SERVICE BULLETIN

TAILBOOM ASSEMBLY OVERLAP INSPECTION AND REWORK

Model 500N and 600N Helicopters, equipped with the part numbered and serial numbered tailboom assemblies listed below.

Tailboom Assembly, P/N 500N3600-501, S/N: 006040-0001 thru 006040-0011.
Tailboom Assembly, P/N 600N3500-507, S/N: 006040-0001 thru 006040-0003,
006040-0005, 006040-0007, 006040-0008.
Tailboom Assembly, P/N 600N3500-509, S/N: 006040-0001 thru 006040-0003,
007604-0001, 007604-0002.

Figure 1. Tailboom Assembly Inspection

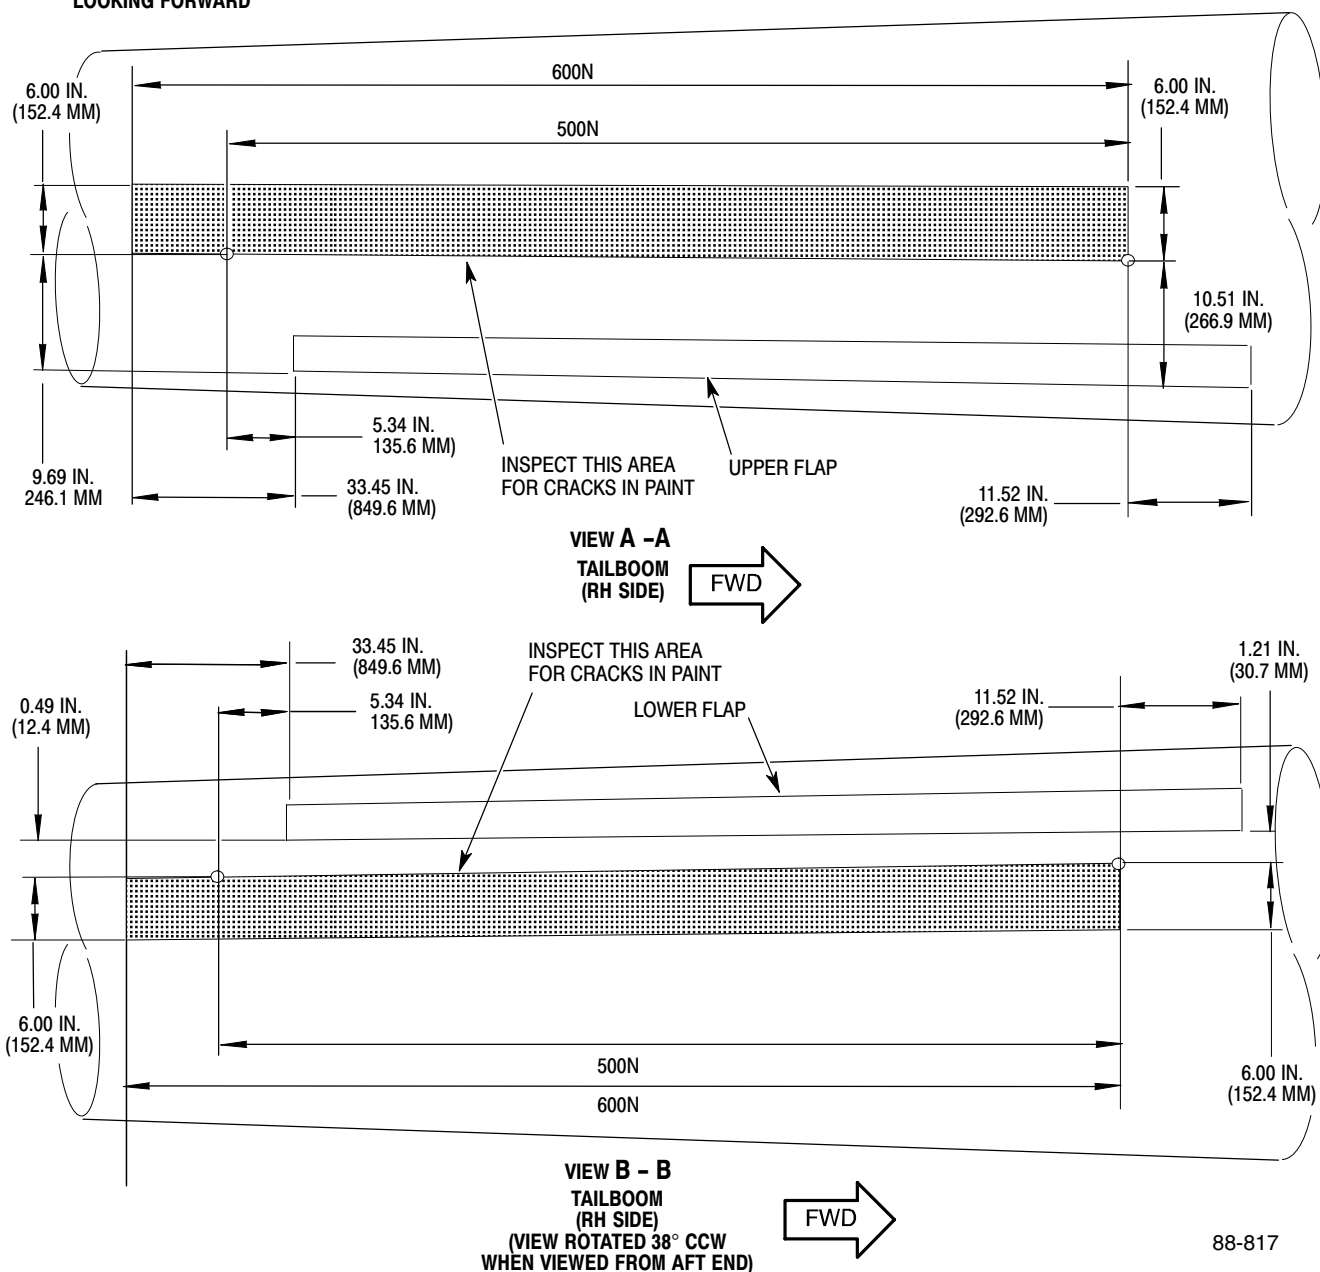
To notify 500N and 600N operators that certain part numbered/serial numbered tailboom assemblies contain overlaps in the outer skin longitudinal splices that do not meet design criteria.

Failure to comply with this Bulletin may result in cracks in the tailboom assembly. This condition could lead to component failure and result in loss of control of the helicopter.

(Ref. Figure 1)

- (1). Visually inspect indicated areas for cracks in paint.
- (2). If cracks in paint are found, contact MDHI Field Service Department for further instructions.
- (3). Repeat this inspection every 25 flight hours until Part 2 of this Bulletin is accomplished.

- (2). Place upper and lower templates on tailboom and secure in place with tape. Mark doubler locations through template eyebrows for forward and aft locations.
- (3). Remove templates from tailboom.
- (4). Mask off repair area to prevent damage surrounding area.
